WATERBURY FILING NO. 1
GRADING EROSION CONTROL PLAN
INITIAL EROSION CONTROL PLAN 2

GRADING EROSION & STORMWATER CONTROL PLAN
INTERIM EROSION CONTROL PLAN 2

WATERBURY FILING NO. 1

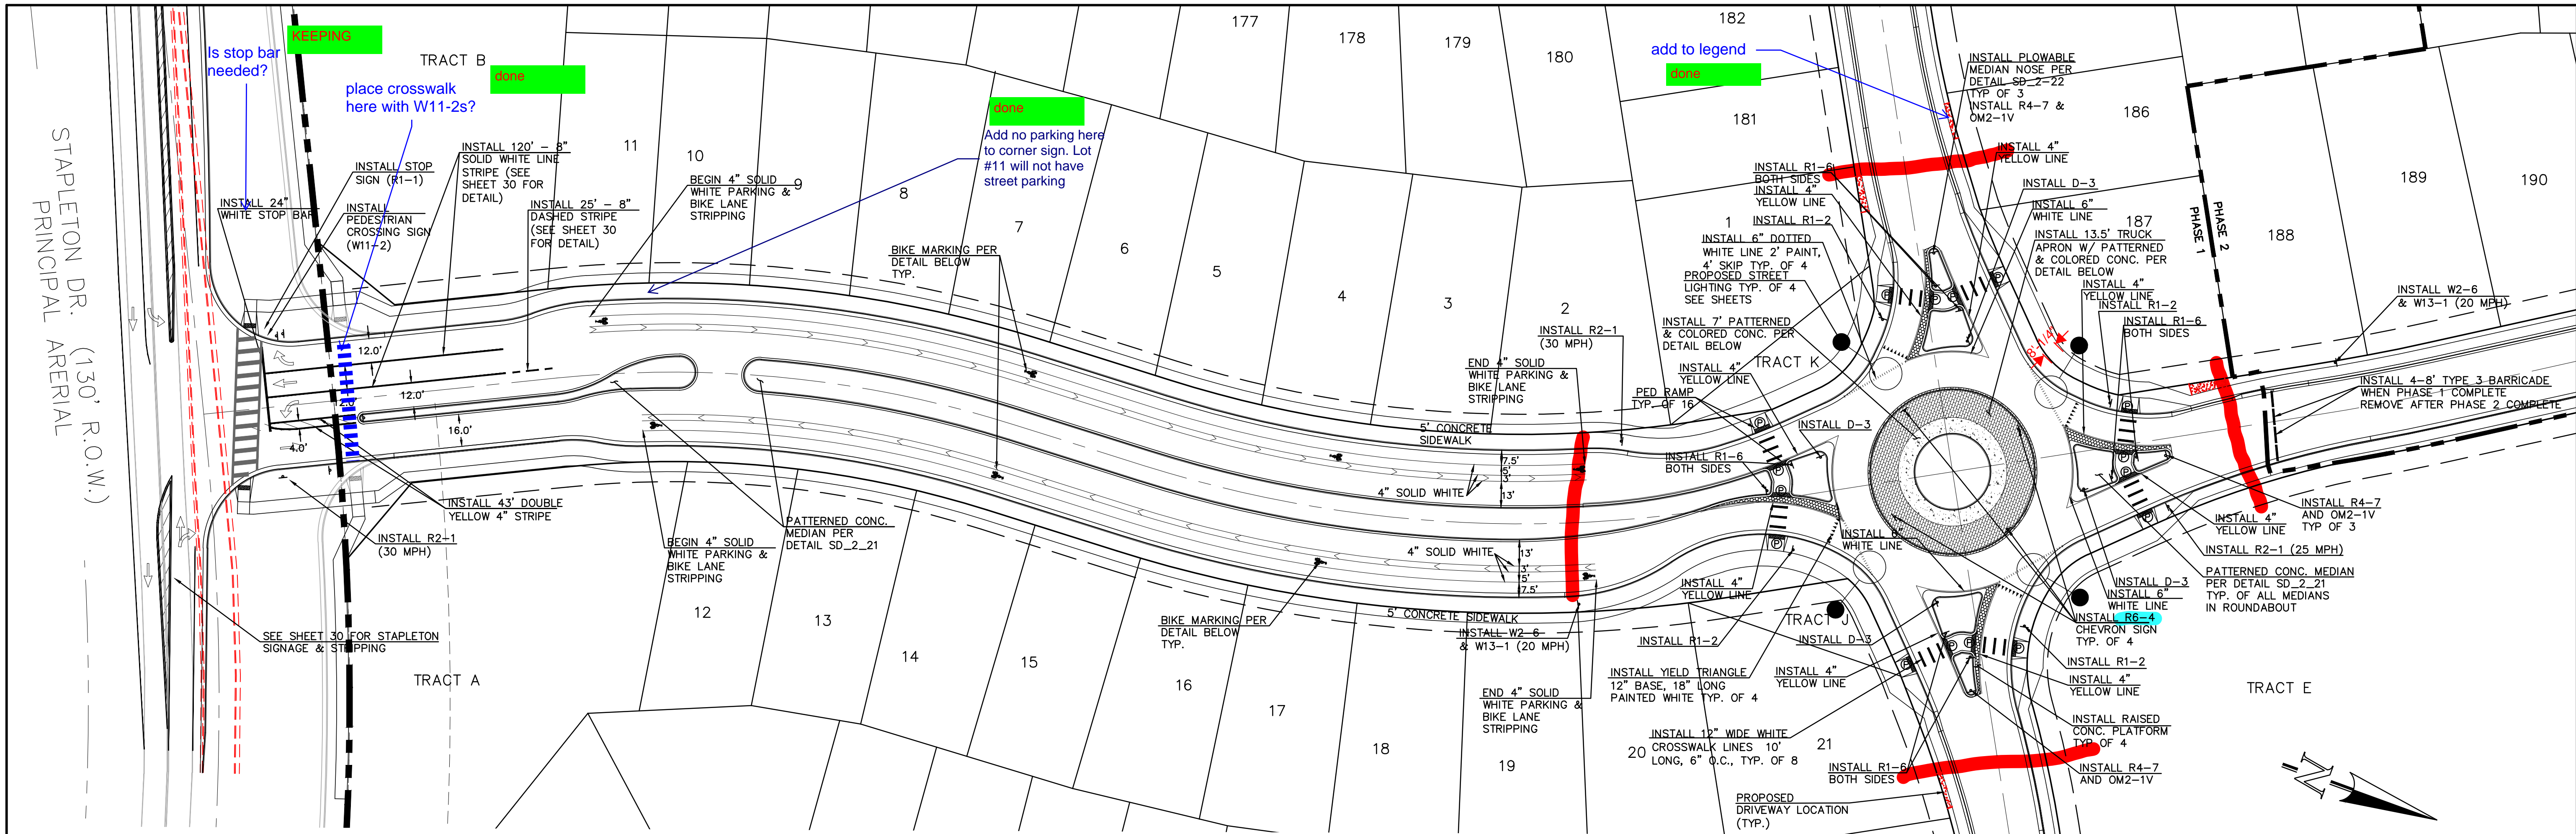
Add "No Parking Here to Roundabout" signs

Add note for letter and sign size at Stapleton intersection

POND 1 CONCRETE MICROPOOL PHASE 1
SCALE: N.T.S.

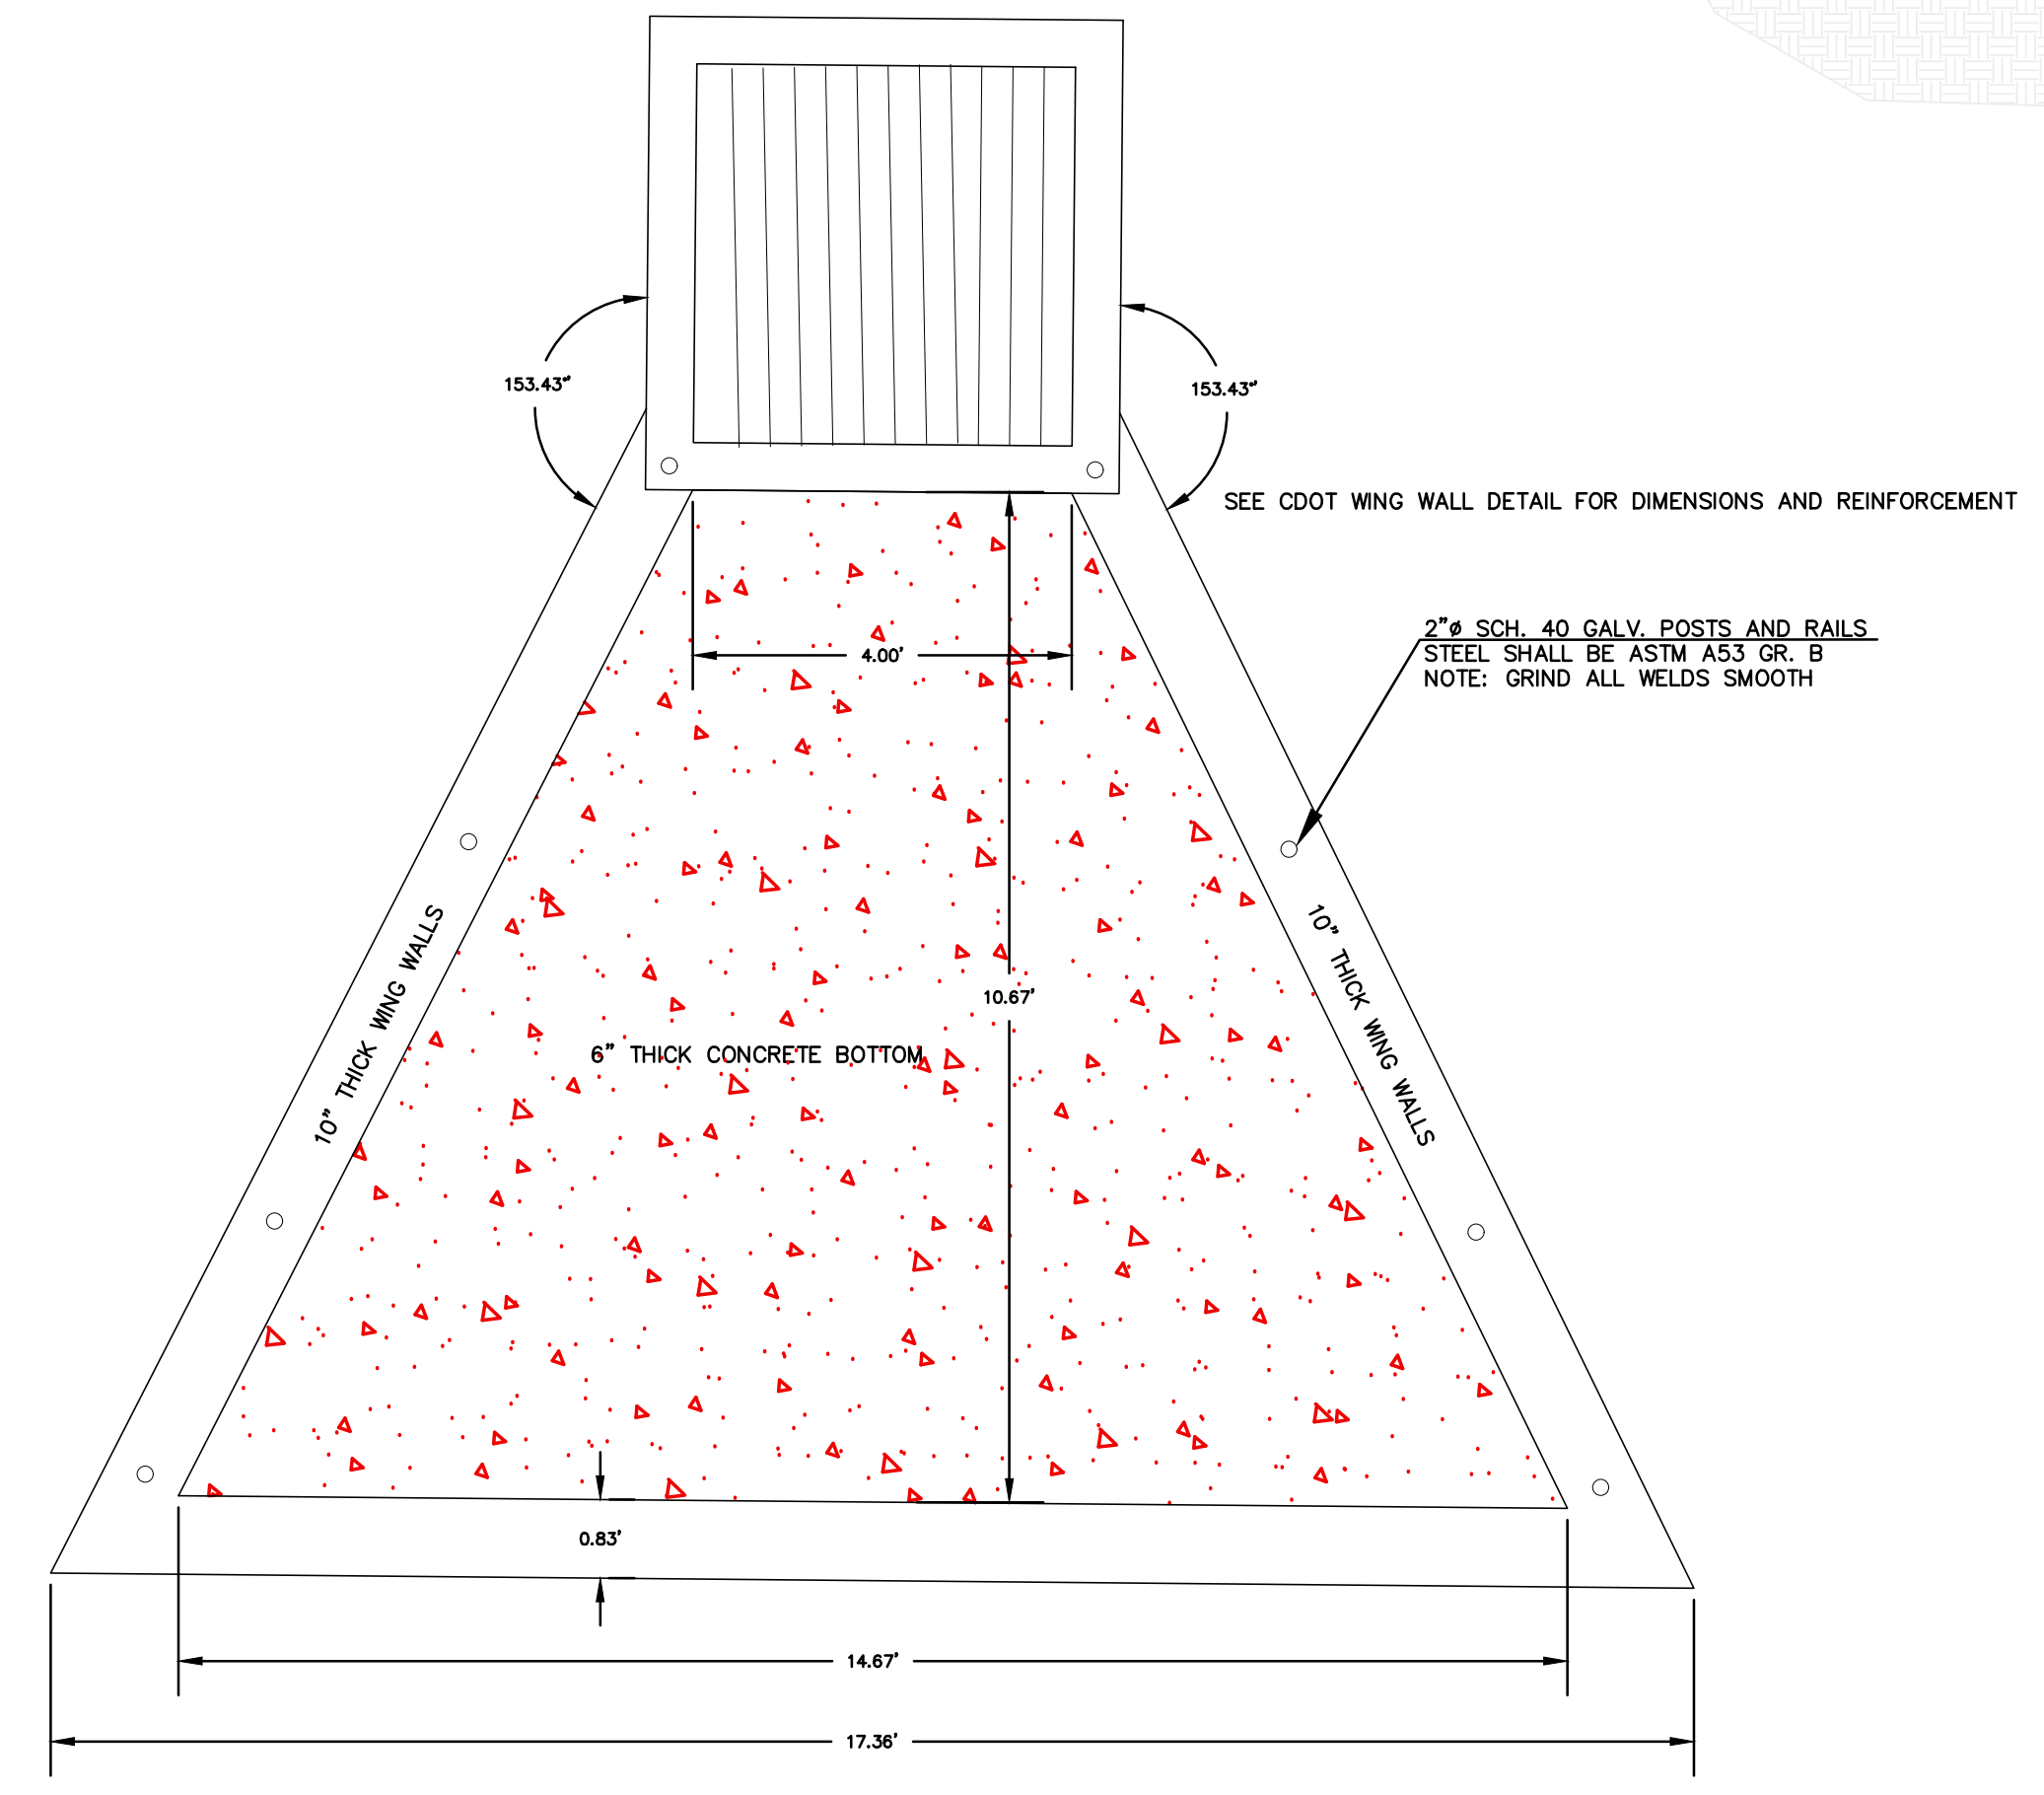
PICKED MHFD DETAIL
Please select which type of trash rack is proposed to be used and provide the specific specifications for the one selected as needed.

POND 1 OUTLET STRUCTURE PHASE 1 MODIFIED TYPE 1 MH
SCALE: N.T.S.

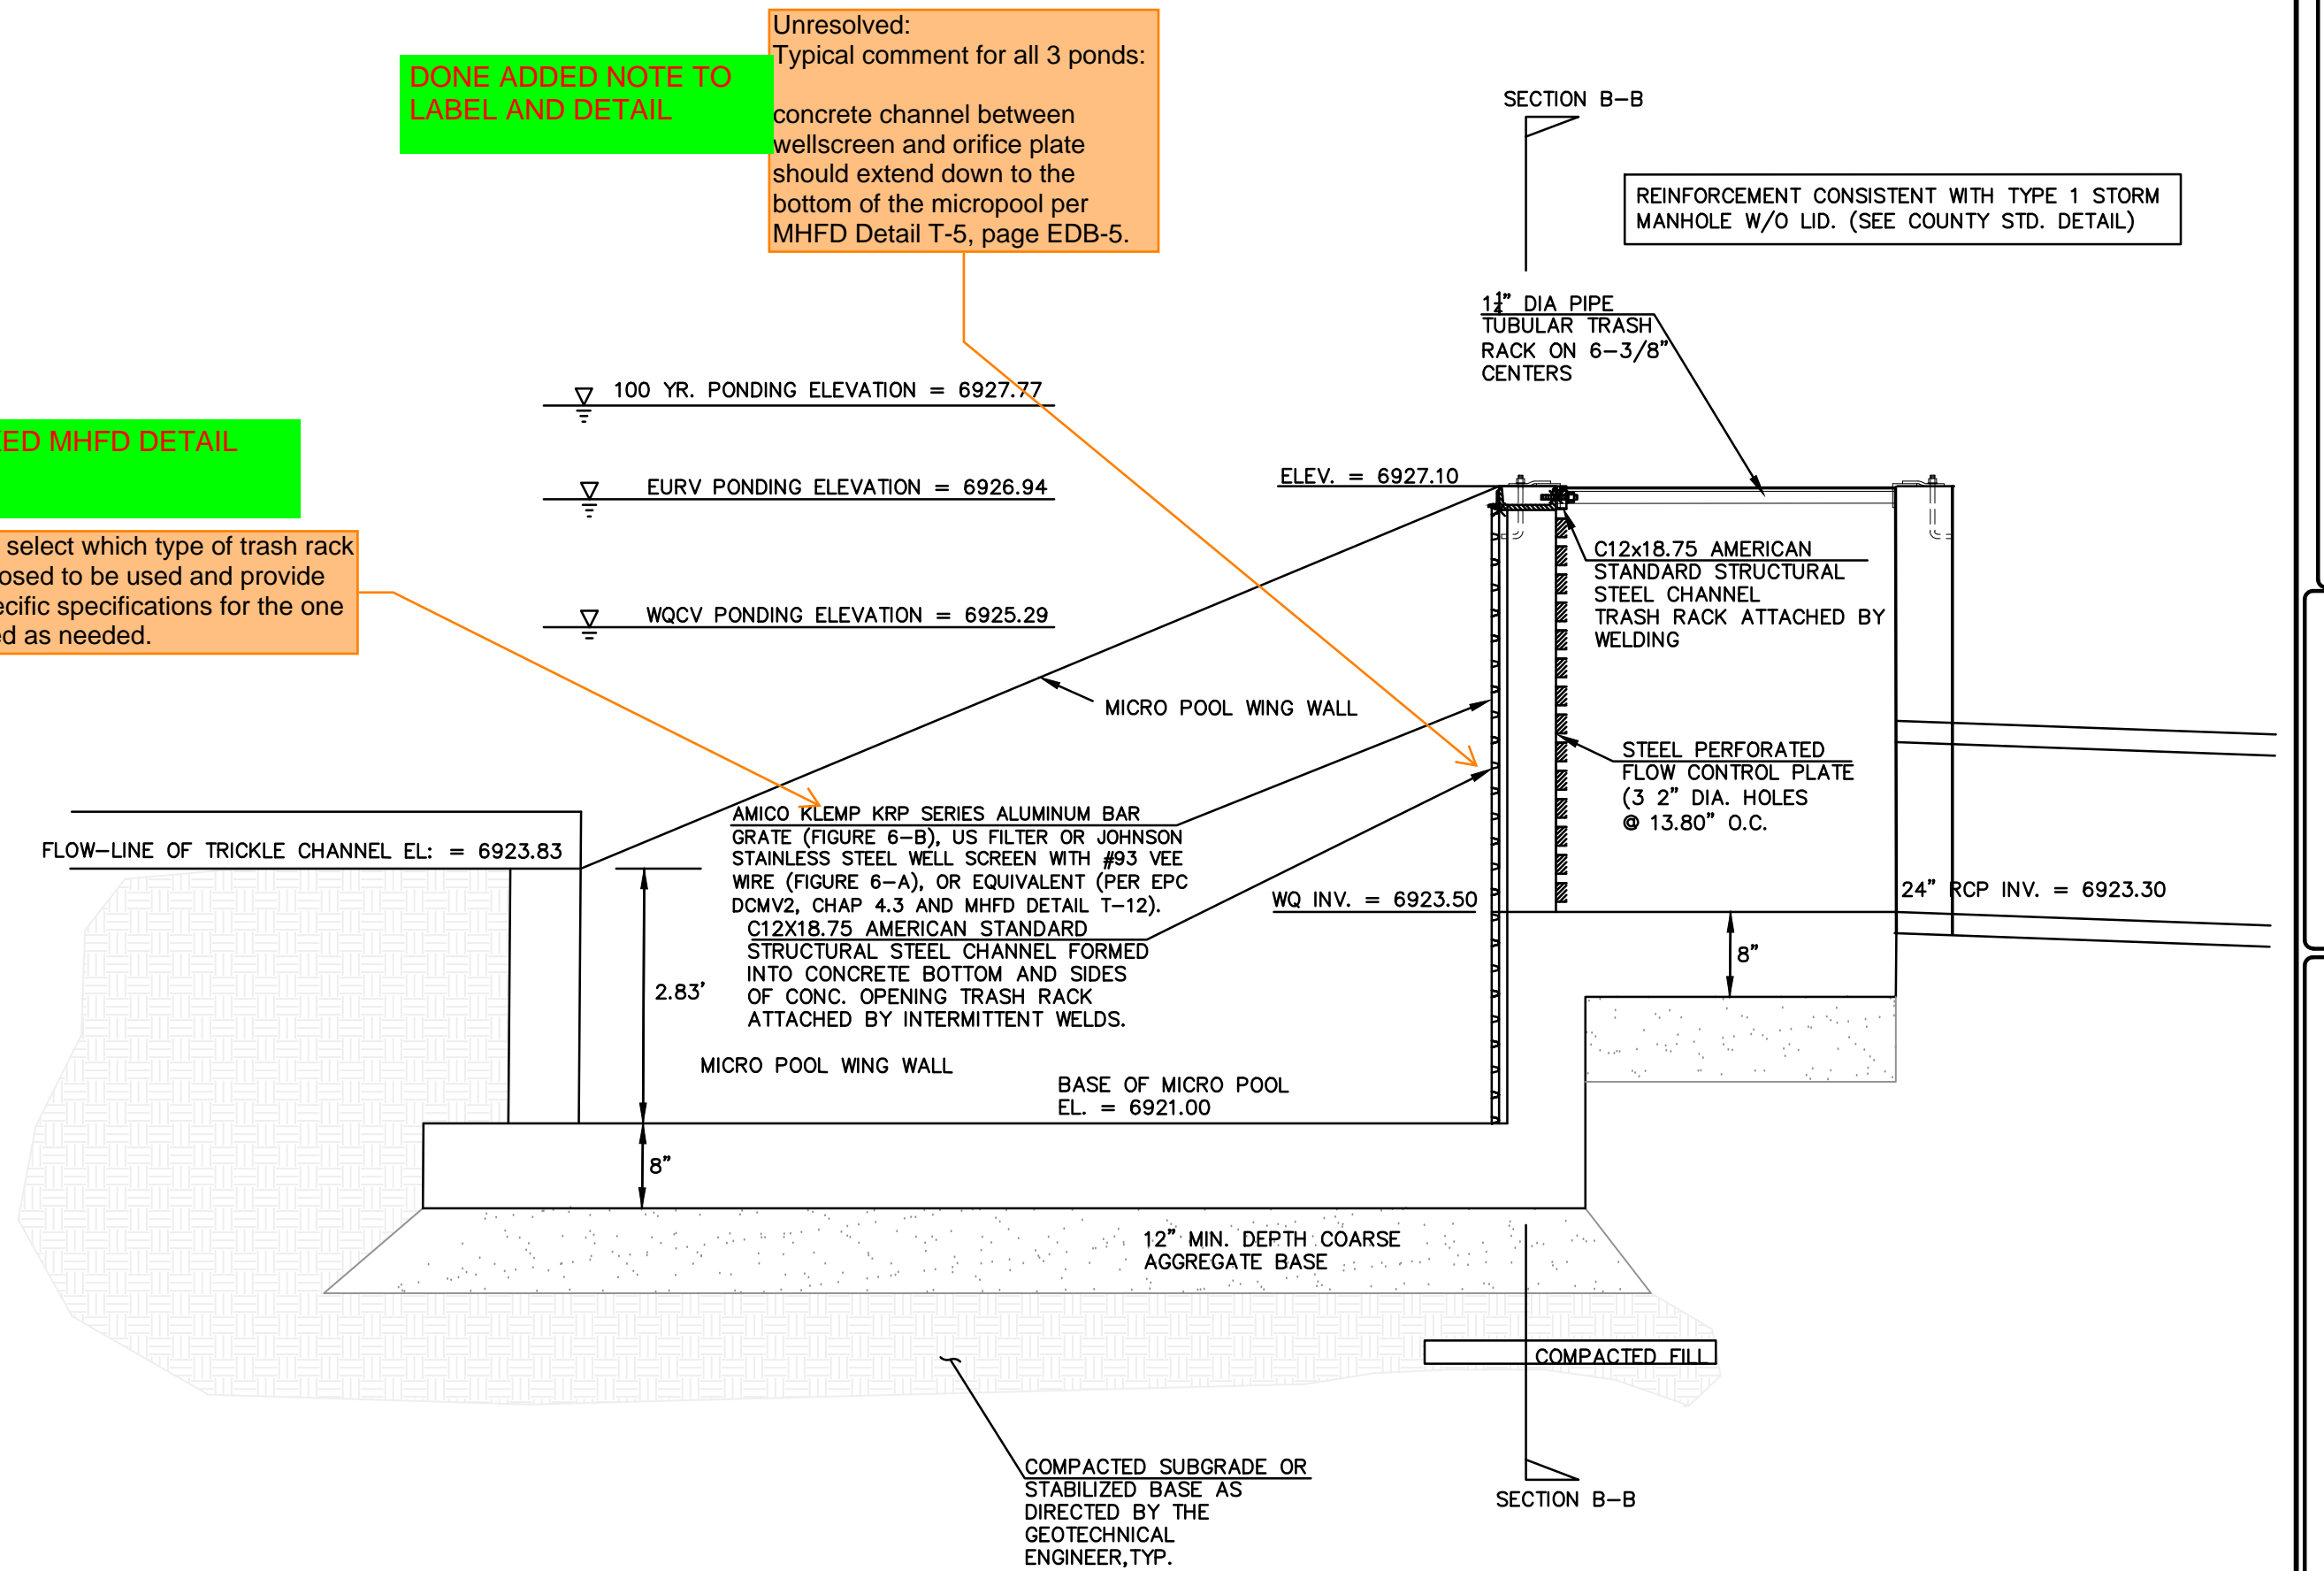
DONE ADD NOTE TO LABEL AND DETAIL
Unresolved: Typical comment for all 3 ponds: concrete channel between wellscreen and orifice plate should extend down to the bottom of the micropool per MHFD Detail T-5, page EDB-5.
